DEPARTMENT OF ENVIRONMENTAL MANAGEMENT
OFFICE OF WATER RESOURCES
FRESHWATER WETLANDS PROGRAM
APPROVED WITH CONDITIONS
AS SPECIFIED IN THE LETTER OF APPROVAL
DATED JAN 25 2013 FILE # 12-0214
NO CHANGES ALLOWED WITHOUT PRIOR APPROVAL
APPROVED PLANS MUST BE AT CONSTRUCTION SITE
Nancy L. Freeman

WETLAND PLAN
A.P. 24 LOT 31
HARTFORD PIKE (ROUTE 101)
SITUATE, RHODE ISLAND
Prepared For:
PAUL J. MATRULLO

REVISION:
DECEMBER 18, 2012
DATE: DECEMBER 14, 2012
DRAWN BY: DCD
SCALE: 1" = 50'
GRAPHIC SCALE
SHEET 1 OF 2 SHEETS
JOB NO. 6534
DWG. NO. 6534-WET1

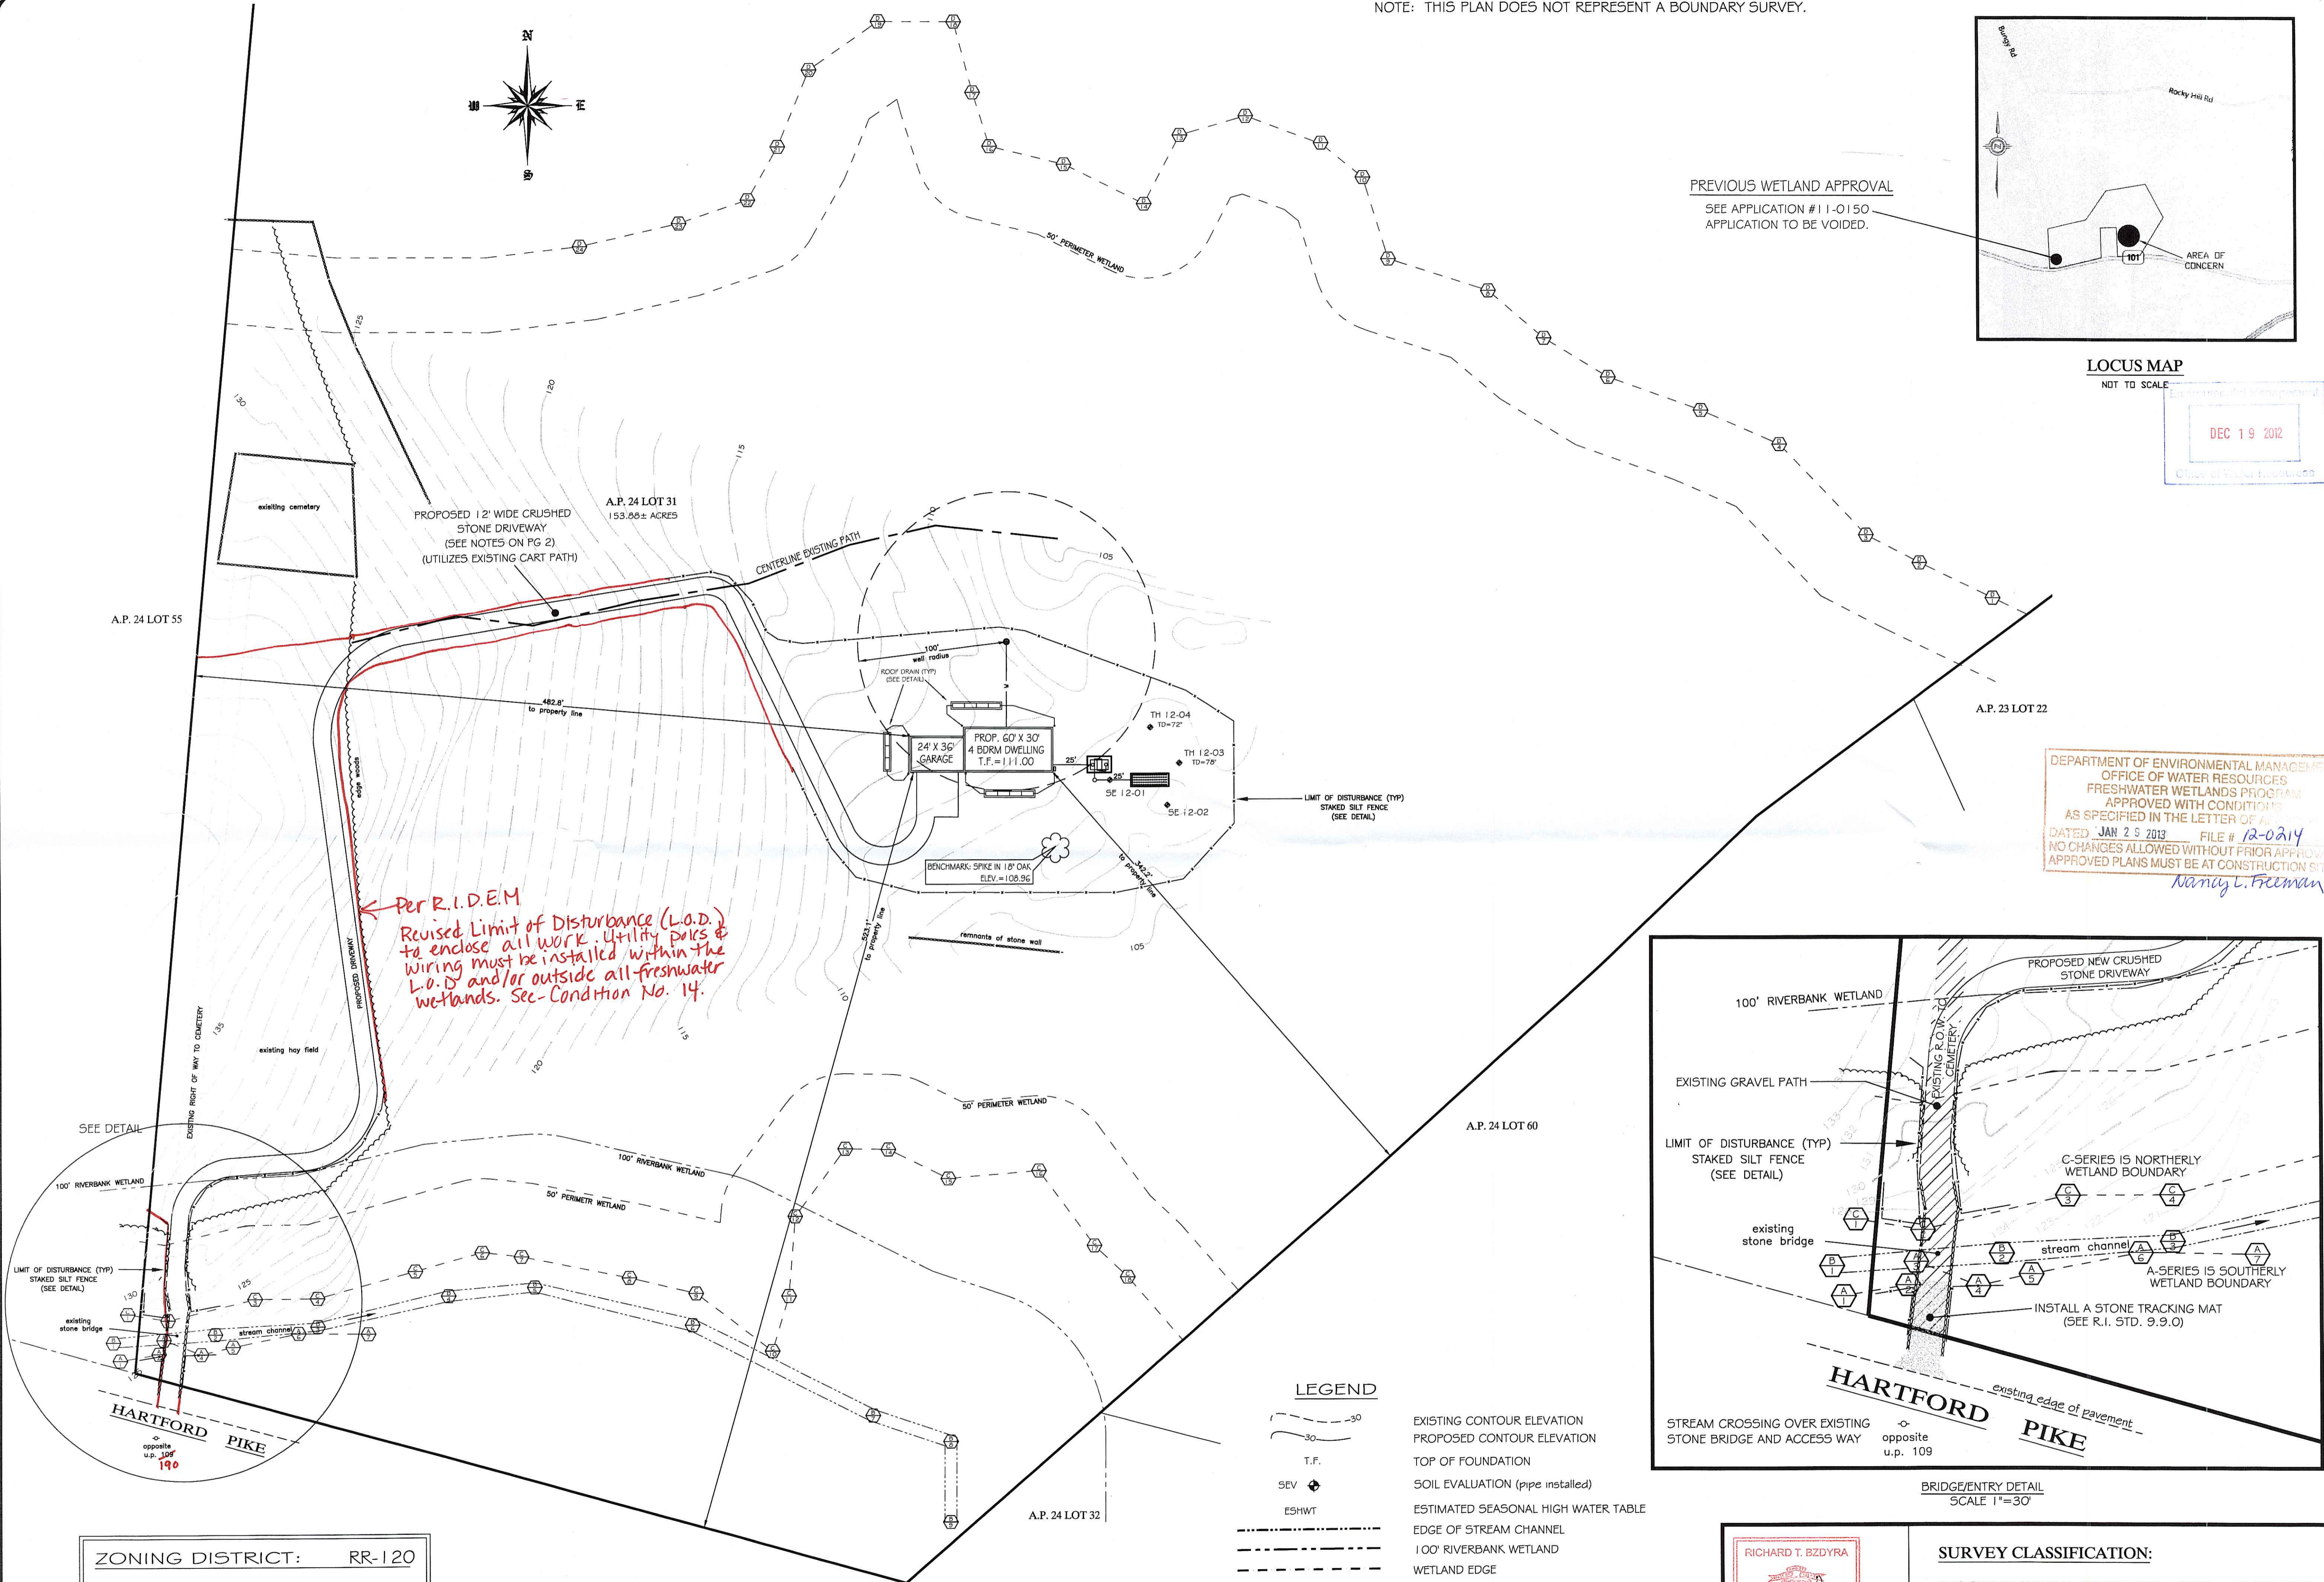
*Per R.I.D.E.M.
Revised Limit of Disturbance (L.O.D.)
to enclose all work. Utility poles &
wiring must be installed within the
L.O.D. and/or outside all freshwater
wetlands. Sec-Condition No. 14.*
